THE OAKLANDS

THE OAKLANDS
 P.O.A.D.P.
 RECEIVED
 93 NOV 23 PM 2:47
 DEPT. OF PLANNING
 AND DEVELOPMENT
 1000 DOWNEY AVENUE
 SAN ANTONIO, TEXAS 78204

RE: Revised The Oaklands Subdivision POADP #385

RE: The Oaklands Subdivision POADP #385

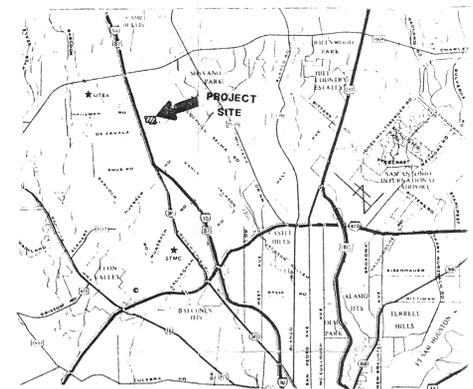
1. A variance will be required at the time of plat submittal regarding section 35-A208, Property line and curb returns at the intersection of Vance Jackson and De Zavala.
2. As previously mentioned, you will be required to dedicate and construct the extension of Vance Jackson in conjunction with the first subdivision plat unit submitted that includes or is adjacent to the Vance Jackson extension.

1. De Zavala ROW width needs to be annotated on the plan as a centerline distance.
2. The extension of Vance Jackson itself needs to be annotated as to the ROW width and pavement width on the plan.
3. Although we appreciate the opportunity to see the street sections, this level of detail is not required on POADPs. Please remove them from the plan itself.
4. A non-access easement is required along both sides of Vance Jackson adjacent to all residential lots.

5. Additionally, please note that once a revised plan is accepted, you will be required to dedicate and construct Vance Jackson in conjunction with the first subdivision plat unit submitted.
